APPLICATION FOR A RESIDENTIAL SITE IMPROVEMENT PERMIT/ CONSTRUCTION AUTHORIZATION FOR AN ON-SITE WASTEWATER SYSTEM, NEW WELL INSTALLATION, OR REPAIR OF EXISTING WELL

3. JOB LOCATION INFORMATION:
TAX PARCEL NUMBER: 02301123
STREET ADDRESS: 5126 Drake Cove Road
CITY: Huntersville
STATE: NC ZIP: 28078
SUBDIVISION NAME:
LOT #: LOT SIZE (acres): .459
TOWNSHIP:
● MECKLENBURG ○ CORNELIUS ○ HUNTERSVILLE
○ DAVIDSON ○ CHARLOTTE ○ PINEVILLE
○ MATTHEWS ○ MINT HILL

CONSTRUCTION AUTHORIZATION

OPERATION PERMIT for an ON-SITE WASTEWATER TREATMENT & DISPOSAL SYSTEM

On-site Wastewater Improvement Permit Diagram

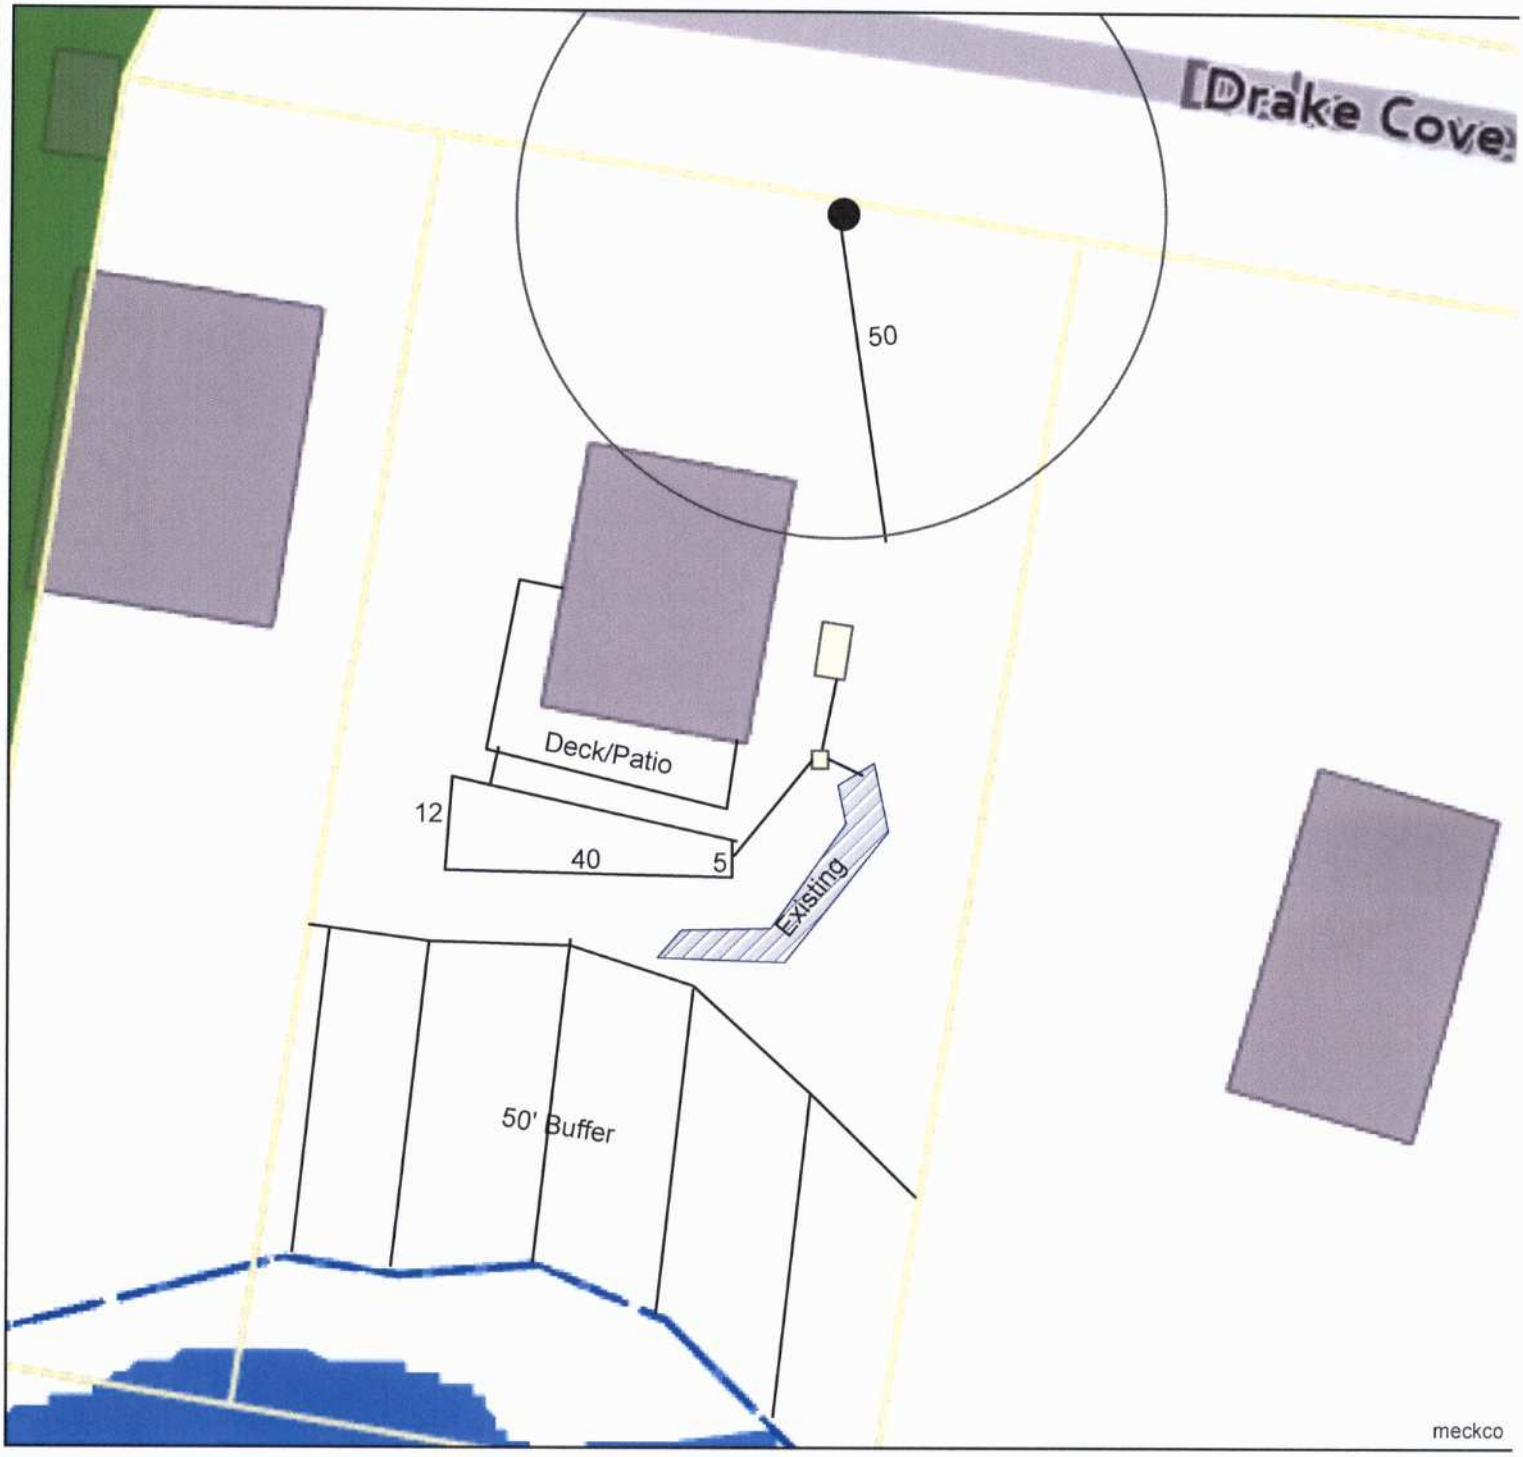
Conditions: install new bed 5' wide at the start 12' wide at the end 40' long. 8inches of sand 24" of stone
MUST PUT UP EROSION CONTROL DURING PERIODS OF WORK. REQUIRED BY CHARLOTTE WATER
PRE CONSTRUCTION REQUIRED PRIOR TO INSTALL. best professional judgement was used to repair the malfunctioning wastewater system
